# **SERVICE LETTER**

## HYDRAULIC BACK PRESSURE REPAIR

### **MODEL 328 FAS**

328 FIRE ATTACK SYSTEMS S/N 001 SL 2007-001

Figure 2

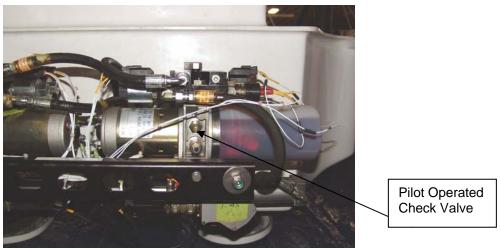
3) There are two hydraulic motor assemblies P/N 000-152803-000 on the Model 328 FAS. Each assembly has two pilot operated check valves located on opposite sides of the manifold. See figure 2.
